Rebuttal to Reports of Dr. Alex Spiliotopoulos and Dr. Remy J.-C. Hennet

Leonard F. Konikow

January 13, 2025

Figure F16. Simulated and observed tetrachloroethylene (PCE) concentrations at water-supply well TT-26, Tarawa Terrace, U.S. Marine Corps Base Camp Lejeune, North Carolina, January 1952–December 1994 (see Figure F6 for location).

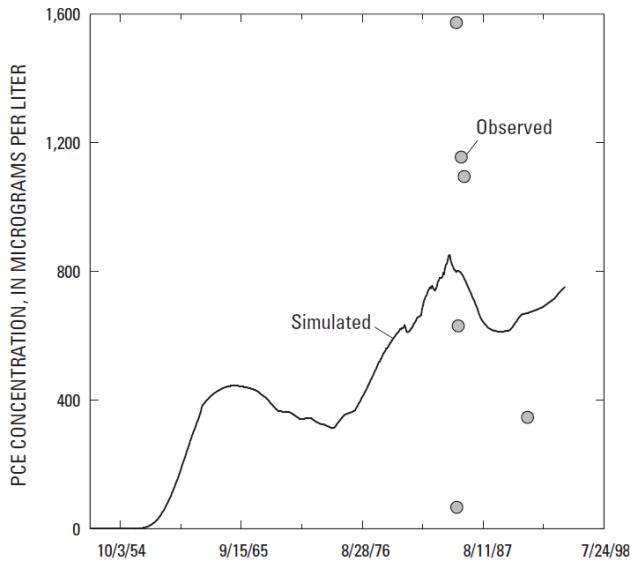
In his summary of Opinion 2 (p. 33), Dr. Spiliotopoulos references his Fig. 5, which includes a reproduction of ATSDR’s Fig. F16 about TT results, and goes on to say that ATSDR’s work resulted in “biased high estimates.” I reproduce that part of Dr. Spiliotopoulos’ Fig. 5 (Fig. F16) here because it actually illustrates the opposite. It shows 5 measured PCE concentrations in samples from well TT-26 collected within weeks of each other in early 1985. Over this relatively short time span, the concentrations varied greatly (bracketed between a high of 1,580 ug/L on 01/16/1985 to a low of 3.8 ug/L on 02/12/1985)—a rate of change that cannot be replicated in a model using monthly time steps. Most importantly, the plot shows that the model results fell almost exactly at the midpoint of the range of observed values (about 800 ug/L)—countering the claim of the model being biased high.

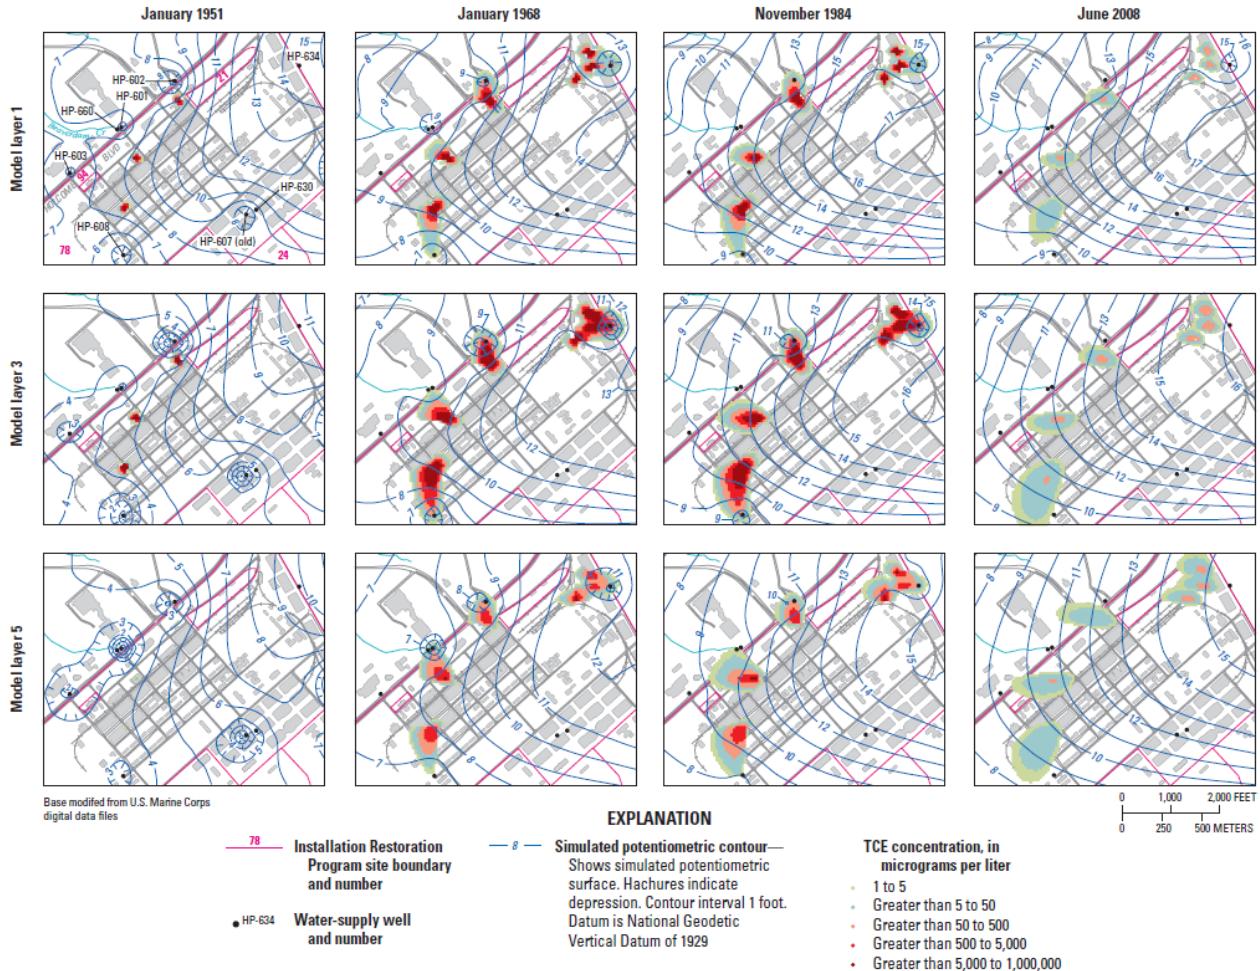
Dr. Hennet argues that this well was not contaminated by TCE because some vials in the shipment were broken (he does not say the samples for this analysis were in broken vials, so the relevancy of other vials being broken is not apparent). I doubt that the lab would or could perform an analysis or report a value on a sample taken from a broken vial. Dr. Hennet says a CCLJ report shows the value as 10 ug/L. However, the lab that did the analysis reported 1,300 ug/L. Hennet and Spiliotopoulos also say that the value of 1,300 is an outlier, so should be discarded. But there are many high-valued “outliers” in the record, and the record shows other instances where the value can change over similar large magnitudes in a very short time (e.g., TT-26 shown in Fig. F16, where the PCE concentration changed from 1,580 to 3.8 ug/L in successive samples collected just 4 weeks apart, mirroring the change in HP-634 from ND to 1,300 ug/L in a similar 4 week timeframe). The reasoning by Dr. Spiliotopoulos and Dr. Hennet to discard this reported value seems entirely speculative. They offer no actual evidence that the analysis or its reporting was erroneous.

Figure C33. Groundwater sample locations for trichloroethylene (TCE) and ranges of TCE concentration in monitor and supply wells within the Hadnot Point–Holcomb Boulevard study area, U.S. Marine Corps Base Camp Lejeune, North Carolina.

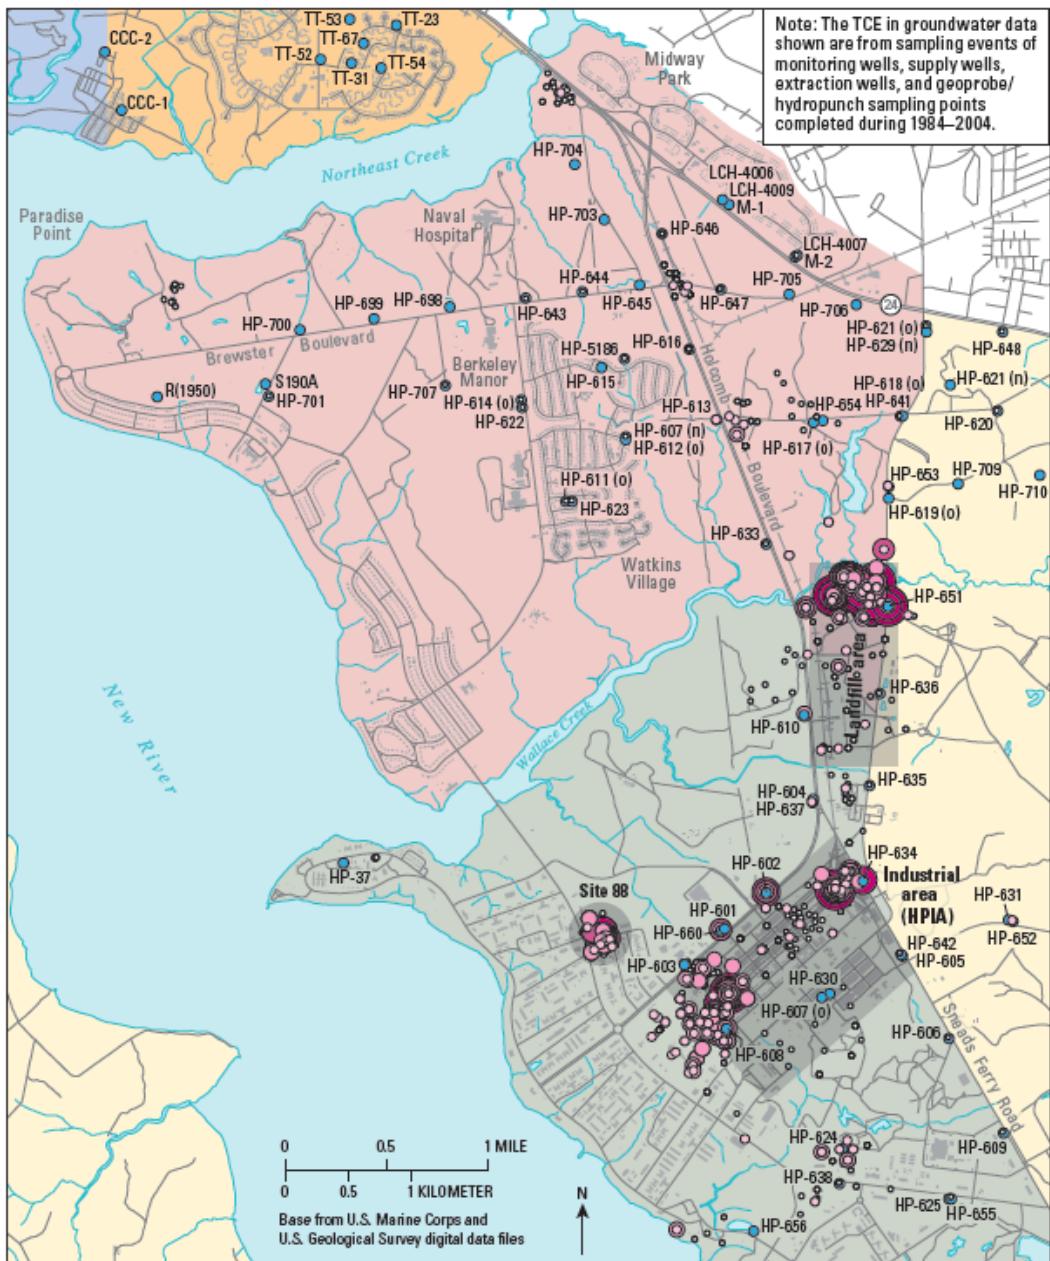
On p. 81, Dr. Spiliopoulos presents his Fig. 31 plotting of TCE concentrations in HP-634. However, he purposely does not include the data point with the value of 1,300 in his plot; including it would yield a very different picture, and show a much better match between simulated and observed TCE at the well location. TCE is found to be present in many locations immediately adjacent to HP-634, as seen in Fig. C33 (reproduced below). HP-634 is within the industrial area HPIA in that map (close to its northeastern boundary).
